**Re: Wiring for Eaton Fuller Ultrashift Transmission  
NHTSA Recall No.: 04V-174  
Kenworth Recall No.: 04KW1**

### **FEDERAL RECALL CAMPAIGN 04KW1**

**W900, T600 AND T800 MODELS BUILT AT THE KENMEX FACTORY FEBRUARY 5, 2003 THROUGH JANUARY 13, 2004 WITH AN EATON FULLER ULTRASHIFT TRANSMISSION**

**Figure 1**

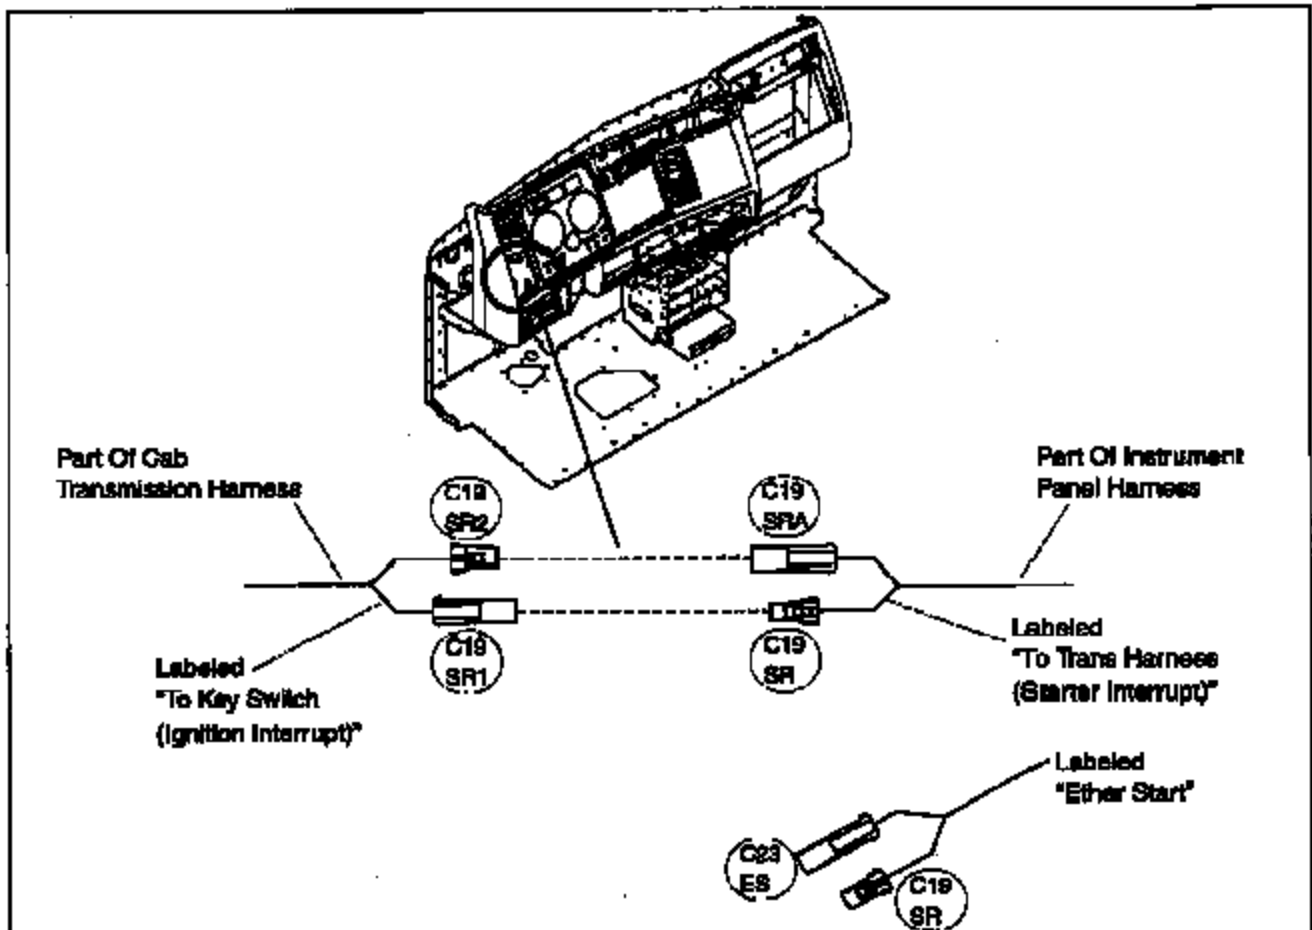
1. Remove fasteners securing Speedometer/Tachometer panel to dash. Move panel back to gain access to IP harness.
2. From behind dash, locate both cab transmission harness connectors labeled "TO KEY SWITCH (IGNITION INTERRUPT)". See Figure 1.

3. If the "TO KEY SWITCH (IGNITION INTERRUPT)" connectors are connected to the IP harness connectors labeled "ETHER START", disconnect them.
4. Reconnect the "TO KEY SWITCH (IGNITION INTERRUPT)" connectors to the IP harness connectors labeled "TRANS HARNESS (STARTER INTERRUPT)".

**NOTE:** Tie back the "ETHER START" connectors to prevent any future technician mis-wiring.

5. Perform Transmission Start Enable Operational Test again to ensure engine will not start when the transmission is in a forward or reverse gear.
